Interactive comment on “Seasonal renewal time variability in the Curonian Lagoon caused by atmospheric and hydrographical forcing” by G. Umgiesser et al.

Received and published: 9 January 2016

Fig. 1. river discharge and ice concentration

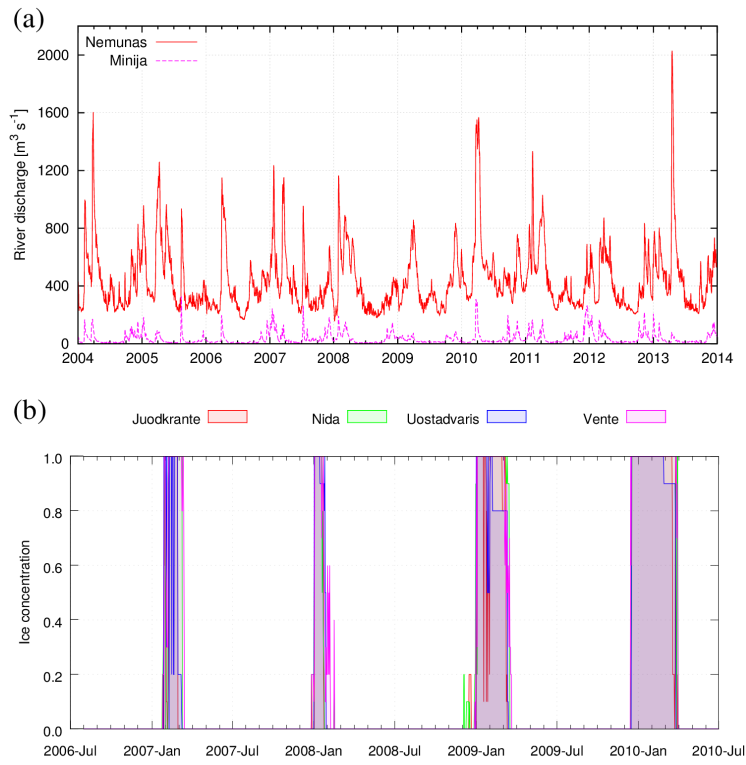
Page 5: List the average discharges of all rivers, even if Nemunas river dominates. A plot of the change in Nemunas discharge with time is necessary to understand its seasonal influence.

Page 12: A plot of the temporal variability of various (especially Namunas) river discharges is essential to understand the results in Figures 4 and 5.

Answer: we will list the discharge of all rivers and will insert a plot of the Nemunas discharge in the lagoon.

Answer: we have included a plot of the various river discharges over the 10 years.
